UNITED STATES PATENT AND TRADEMARK OFFICE

APPLICATION NO.	FILING DATE	FIRST NAMED INVENTOR	ATTORNEY DOCKET NO.	CONFIRMATION NO.
10/685,309	10/14/2003	Philip Andrew Frank	005127.00467	9840
22909	7590	10/12/2004	EXAMINER	
BANNER & WITCOFF, LTD. 1001 G STREET, N.W. WASHINGTON, DC 20001-4597			MITCHELL, KATHERINE W	
			ART UNIT	PAPER NUMBER

Office Action Summary

DETAILED ACTION

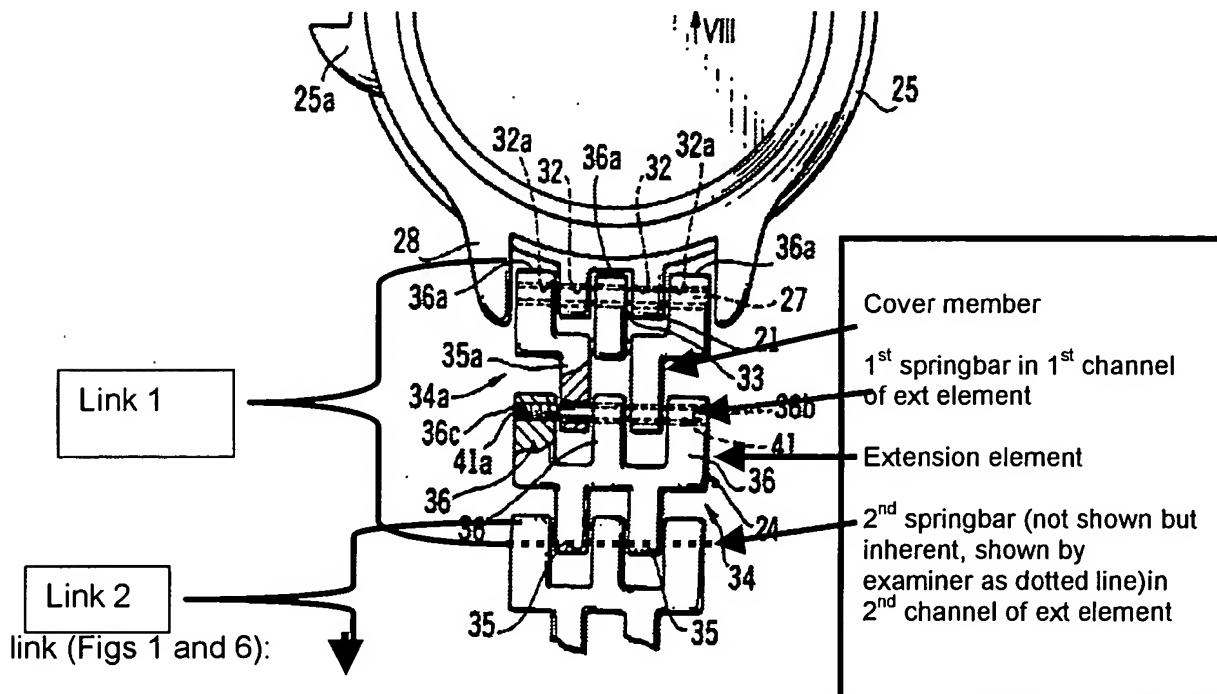
Re claim 29 and 46: Kikuchi teaches a wrist worn timepiece (inherent in watchband, as shown in Figure 1) comprising a case (1) defining a recess and a timing element positioned within the recess (annular middle 5 for movement of a watch to be mounted) (col 2 lines 40-43).

A band (4) extends from at least one side of the case (col 2 lines 62-64), the band having a plurality of links, each link having a cover member, an extension element, a 1st springbar extending through a first channel in the extension element to secure the extension element to the cover member, and a second springbar extending through a second channel in the extension element to joint the extension element to an adjacent

Note that col 4 line 32 specifically states that a pin, springbar, or screw are equivalent connectors. Note that the two channels are parallel

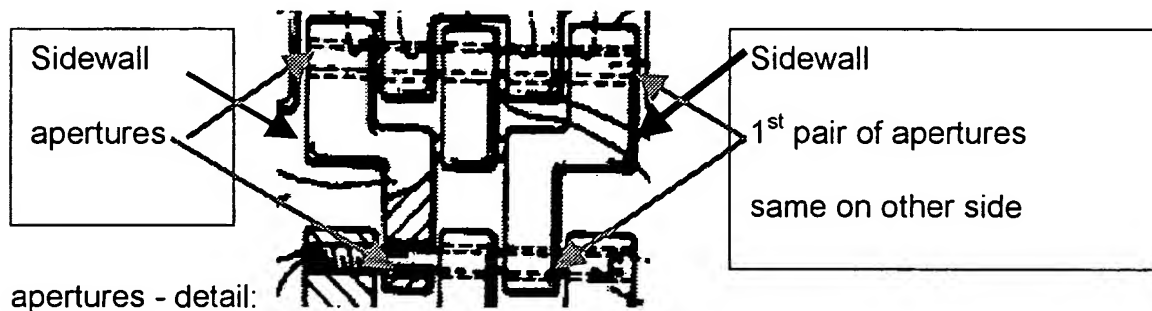
Re claim 35: the cover member (see Fig above) has a first pair of apertures that receive end portions of the first springbar to secure the extension element to the cover member (springbar shown as passing thru, and described in col 4 lines 22-33, with cover being called 34a and extension member being called 34). Note that col 4 line 32 specifically states that a pin, springbar, or screw are equivalent connectors.

Re 36: Figure 6 shown above shows the cover member with a primary surface (center top portion between the two bent sidewall portions) and a pair of sidewalls extending outward from primary surface, each sidewall defines one of the pair of

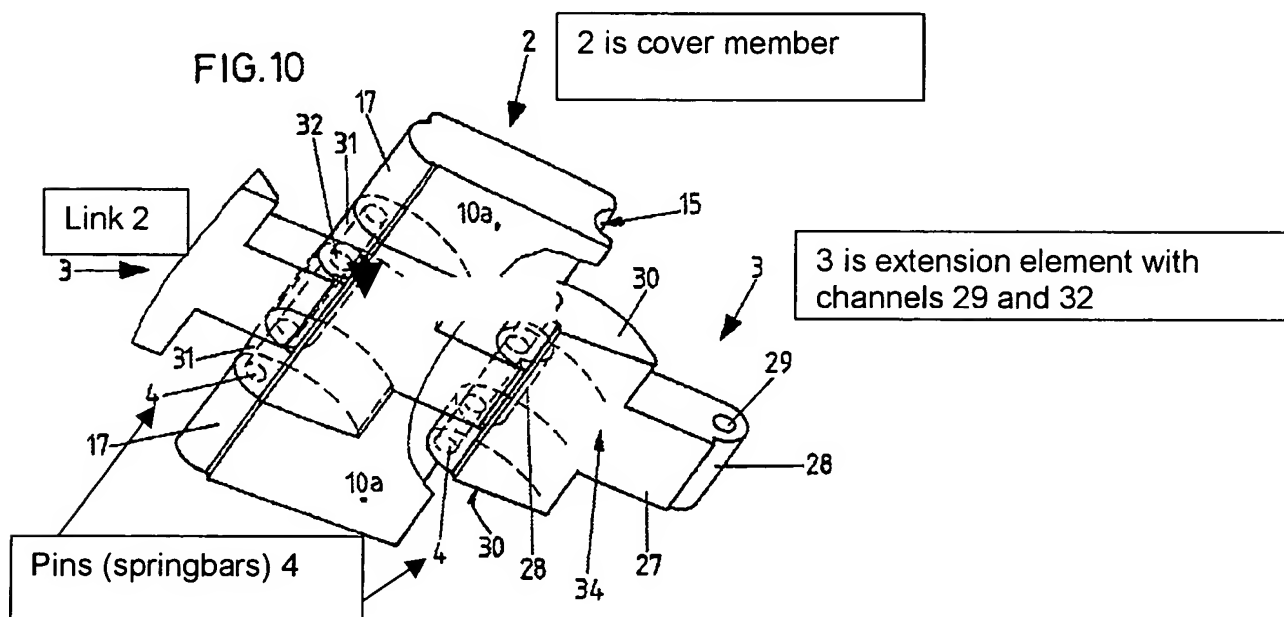
Re claims 37-38 - Fig 6 shows the joining to adjacent separate elements and cover member configured to join with end members of adjacent springbar.

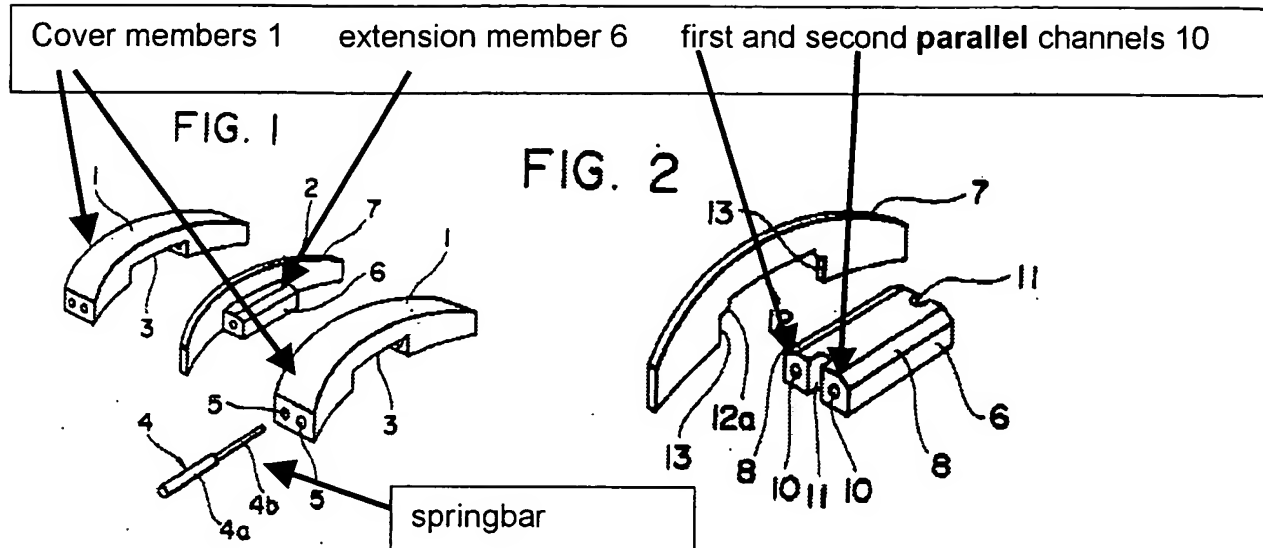
Re claims 29-30 and 42 and 46: Koenuma teaches a watch band with a plurality of links (col 1 lines 32-48) extending from at least one side of a case (15), each link including a cover member (1), an extension element (6) a 1st bar (4) extending thru a first channel (10) in the extension element to secure the extension element to the cover member, and a 2nd bar extending through a 2nd parallel channel in the extension element to join the extension element to an adjacent link. Examiner notes the broadest definition of channel does not require a through channel.

Re claims 32, 35-38 and 48: The Figures above from Koenuma show the springbars through the apertures and adjoining the extension element with the case or cover member. The sidewalls with apertures are best seen in Fig 1, also above.
